VOLUNTARY RECALL CAMPAIGN

Classification: BT26-001	Reference: NTB26-005	Date: January 27, 2026
-----------------------------	-------------------------	---------------------------

VOLUNTARY SAFETY RECALL CAMPAIGN 2025-2026 ALTIMA, FRONTIER, KICKS, 2025 SENTRA; DOOR STRIKER REPLACEMENT

CAMPAIGN ID #: PD185 and PMA61
APPLIED VEHICLES: 2025-2026 Altima (L34)
2025-2026 Frontier (D41)
2025-2026 Kicks (P16)
2025 Sentra (B18)

Figure 1

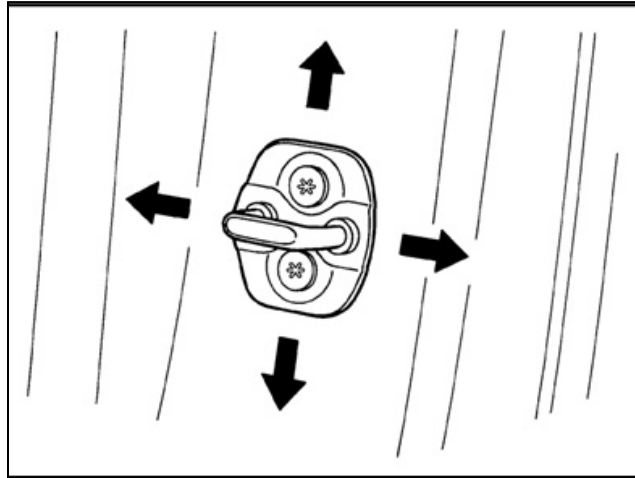
3. Loosen the door striker retaining bolts.
4. Adjust the door striker so that it becomes parallel with the door lock insertion direction.
5. Tighten the door striker retaining bolts.
 - Door striker retaining bolt torque: 16.7 N•m (1.7 kg-m, **12 ft-lb**)
